Village of Arlington Heights, IL  
Department of Building & Life Safety

P.C. Number: 18-018

Project Name: Special Use Permit Amendment Round 2

**PLAN COMMISSION PC #18-018**  
**Taco Bell Rebuild**  
**1530 W Algonquin Rd**  
**Preliminary Plat of Subdivision**  
**Round 2**

TECHNICAL GUIDANCE MANUAL	
	PLATE RESTRICTOR DETAIL (INSTALLED IN MANHOLE/CATCH BASIN)	
	7/1/15	
	STD. DWG. NO. 24	
	PAGE NO. 25

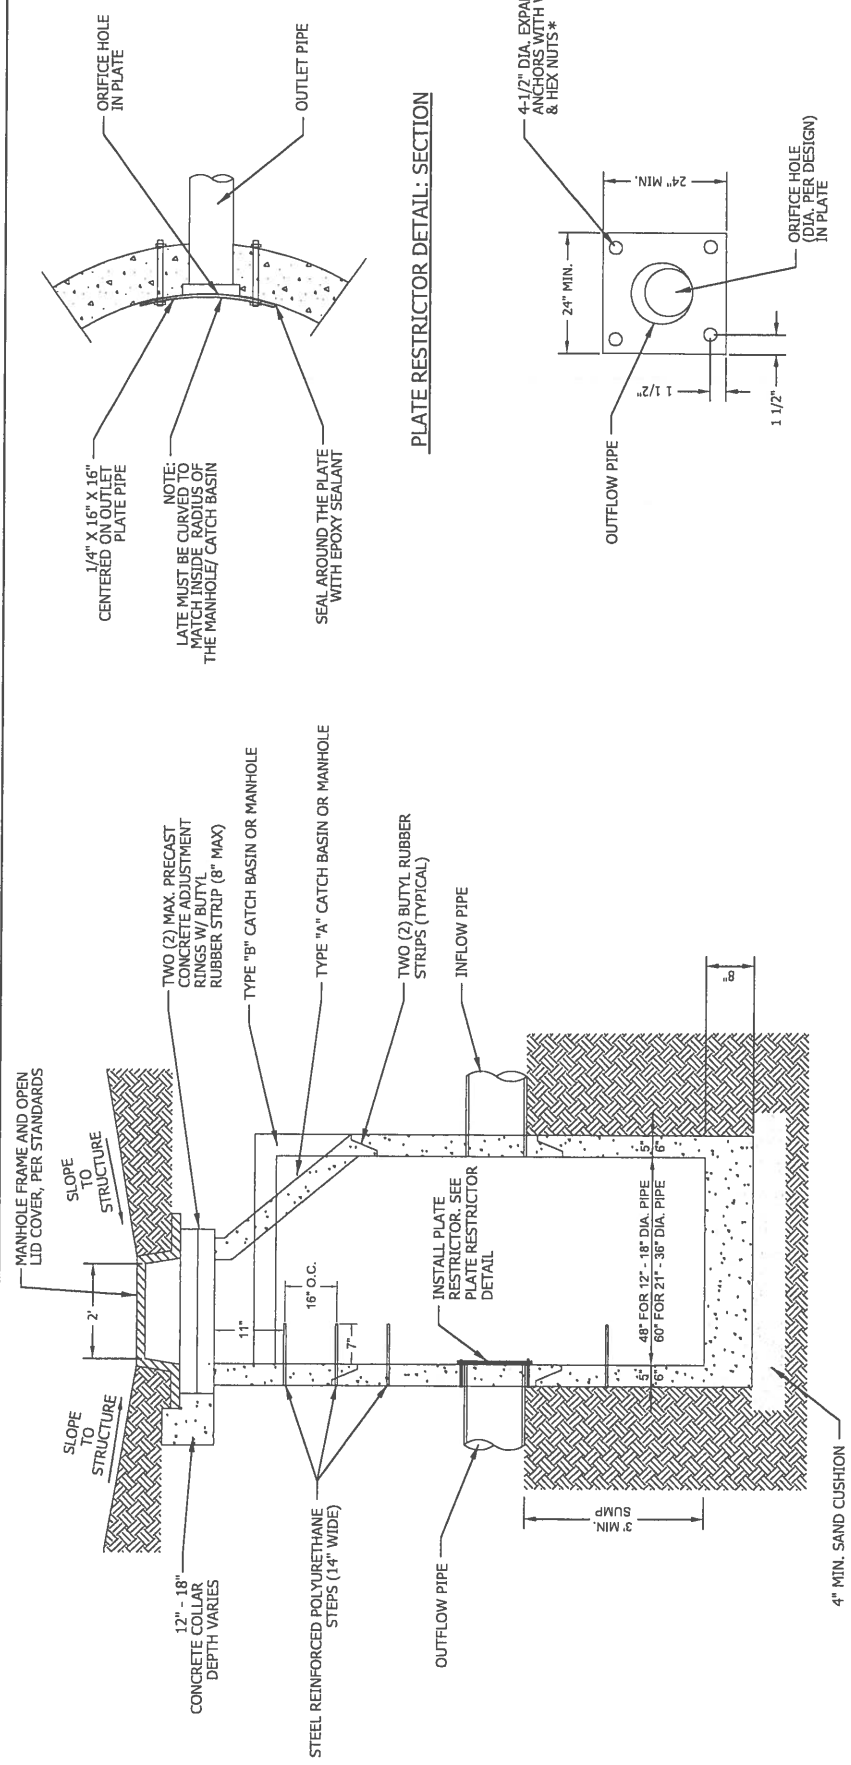
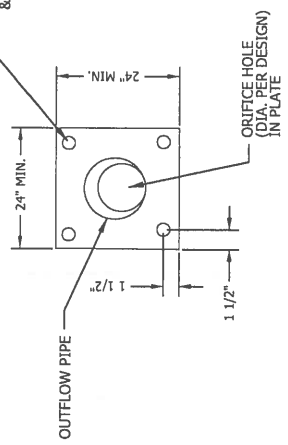
13. The petitioner's response to comments #1- #3 are acceptable.
14. The petitioner's response to comment #4 is noted. Regarding the restrictor detail shown on sheet C-6, the restrictor should be installed vertically and a hood should be constructed over the outlet pipe. For reference, enclosed are a plate restrictor detail and hood detail from the Metropolitan Water Reclamation District. The revisions to the restrictor and the detention calculation verification for the fee in lieu of detention can be addressed at final engineering for the permit.
